Before The Hearings Panel for
Central Otago District Council

IN THE MATTER Application by Clutha Plains Trust regarding the
Resource Consent Application of 5 Māori Point Road,
Tarras

Statement of Evidence of Julie Patricia Greenslade

Appendix B – Landscape Plan Amendments

DRAWING NO.
 TRE001-DWG-LND-100
REVISION NO. E

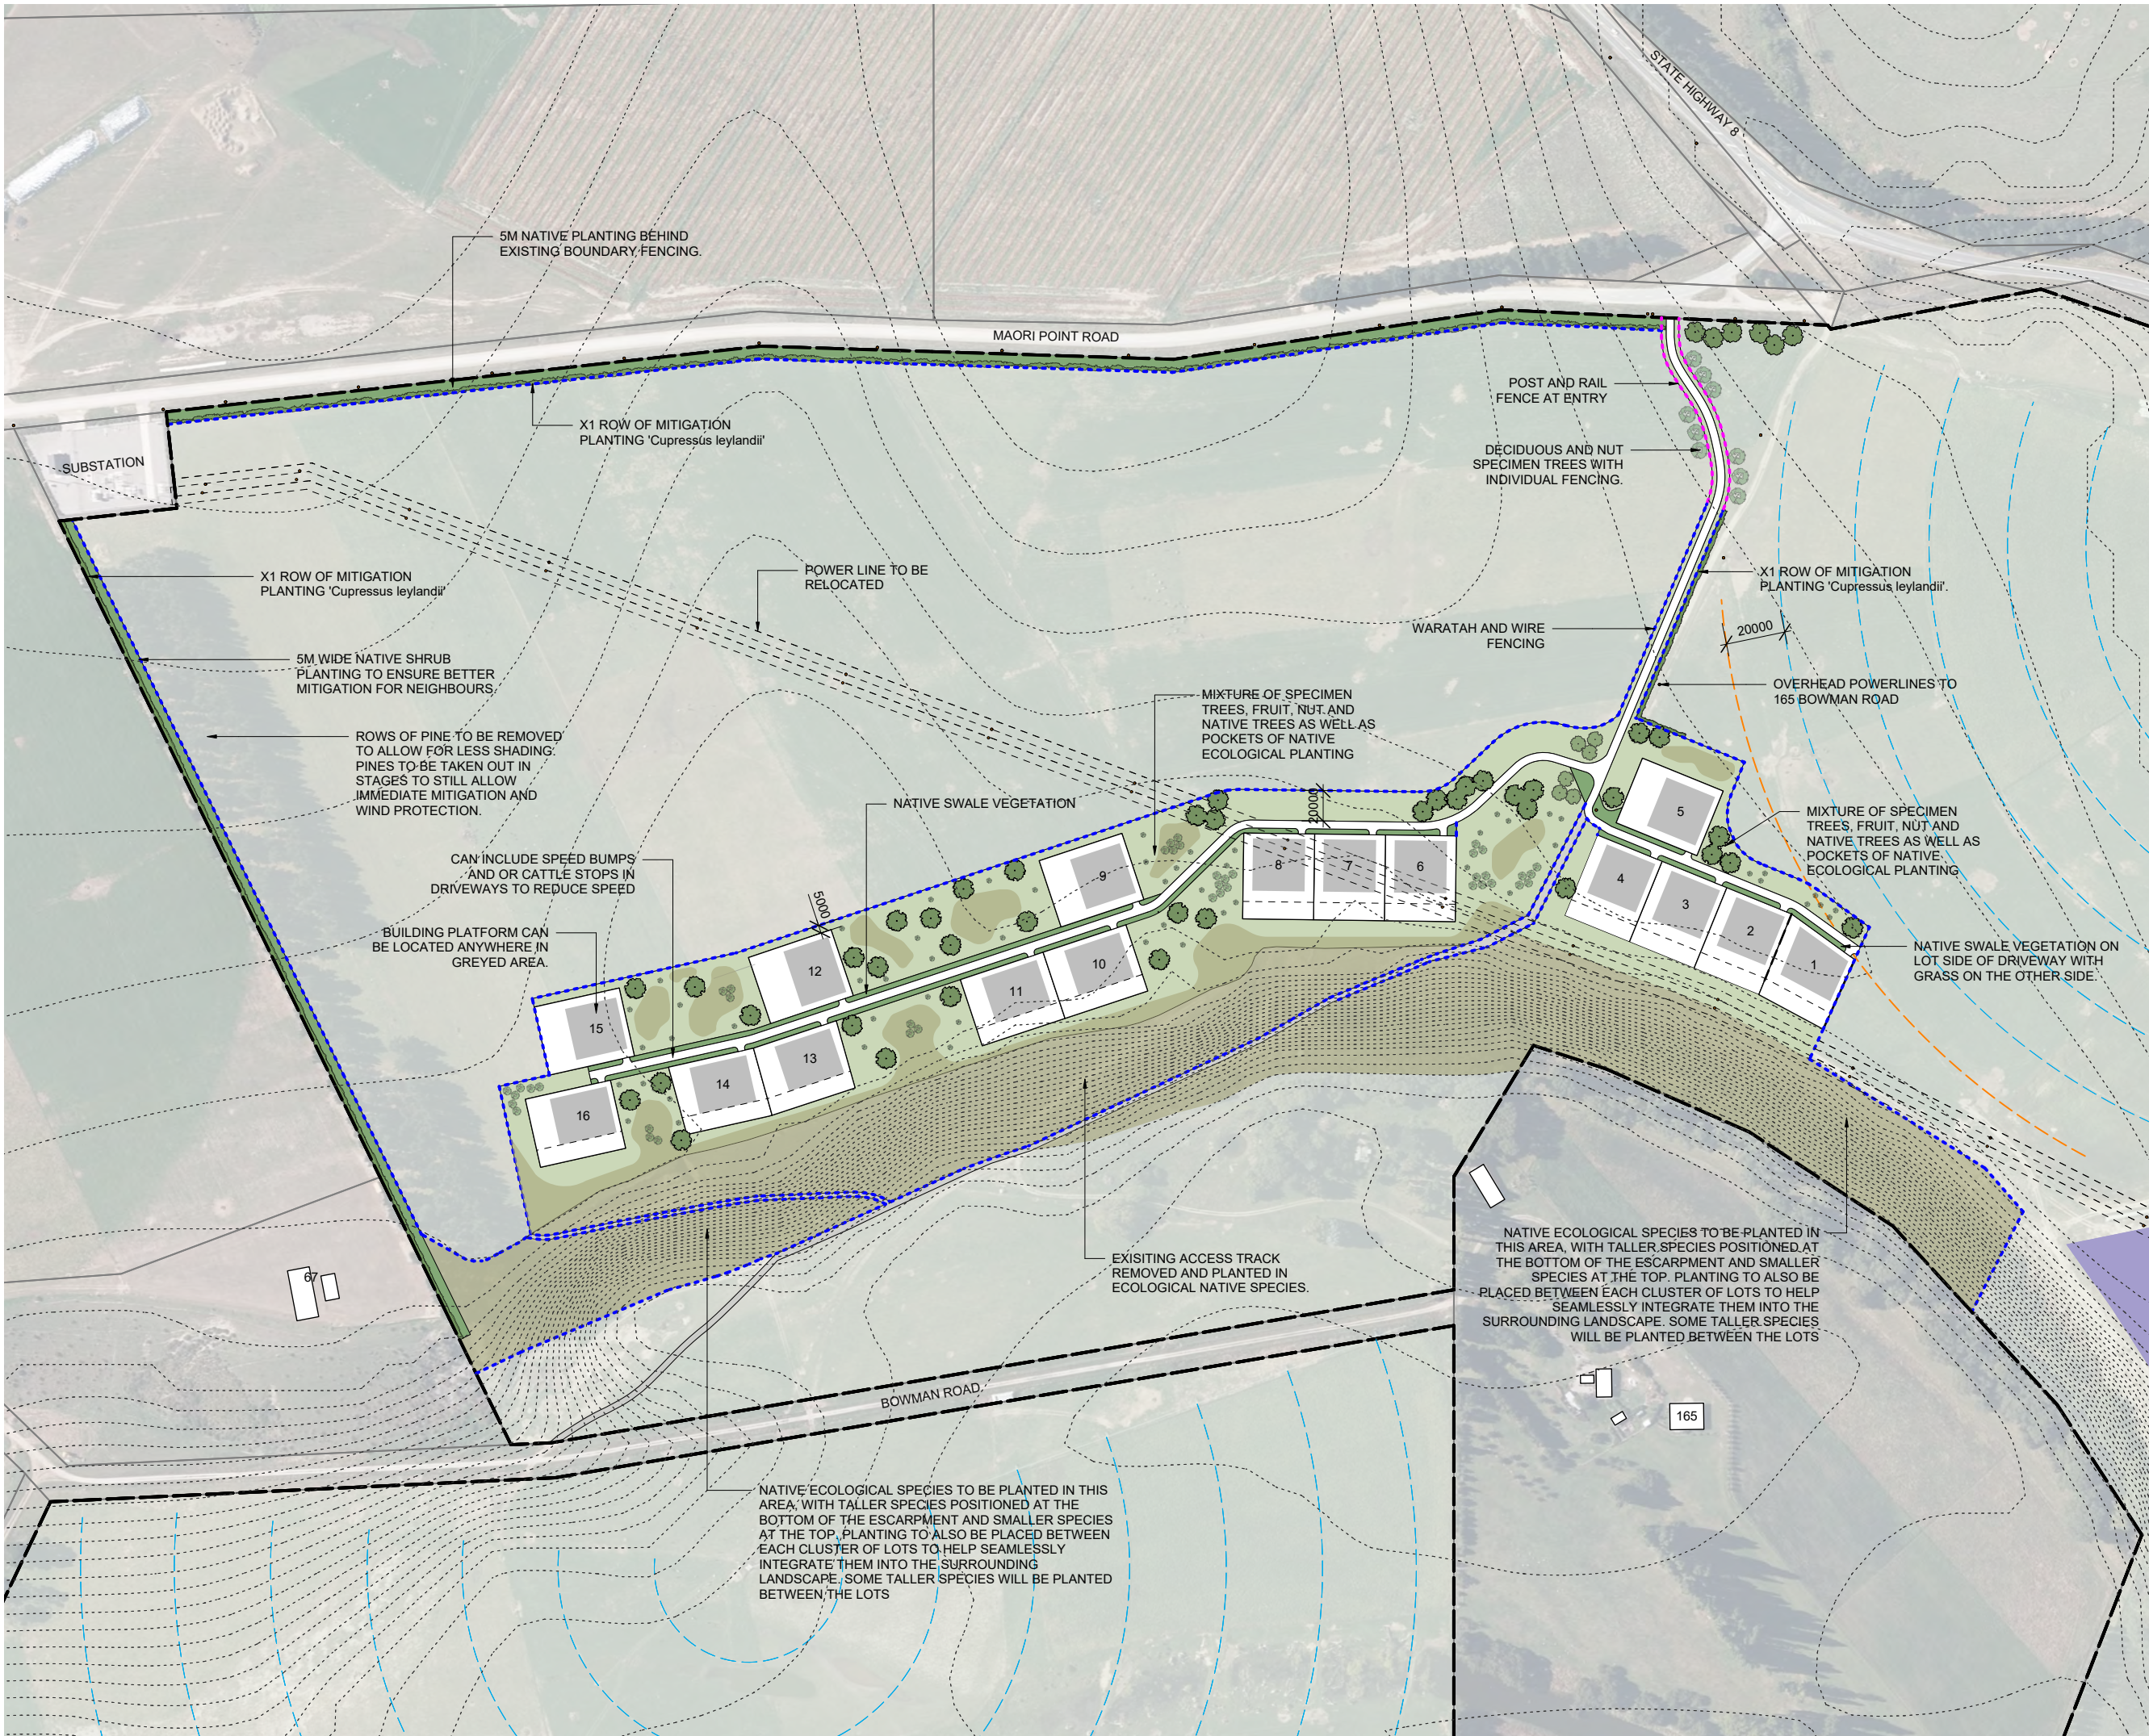
- 18 In response to the concerns raised in the peer review and Section 42A report, amendments have been made to the landscape plan to further enhance integration and reduce perceived density. These amendments can be found in Appendix B. Below is a summary of amendments:

- (a) Some lots have been pushed further back from the terrace edge to reduce their visibility from lower vantage points.
 - (b) Certain lots have been shifted behind others to break up the perceived linearity of the built form and consolidating it whilst, still allowing for views.

- (c) Gaps between lots have been increased, ensuring greater separation between clusters.
 - (d) Ecological planting has been extended into the open spaces between clusters, softening the development pattern and further integrating it into the surrounding landscape.

NATIVE ECOLOGICAL SPECIES TO BE PLANTED IN THIS AREA. WITH TALLER SPECIES POSITIONED AT THE BOTTOM OF THE ESCARPMENT AND SMALLER SPECIES AT THE TOP. PLANTING TO ALSO BE PLACED BETWEEN EACH CLUSTER OF LOTS TO HELP SEAMLESSLY INTEGRATE THEM INTO THE SURROUNDING LANDSCAPE. SOME TALLER SPECIES WILL BE BETWEEN THE LOTS.

ACCESS TRACK REMOVED AND PLANTED IN NATIVE ECOLOGICAL SPECIES.
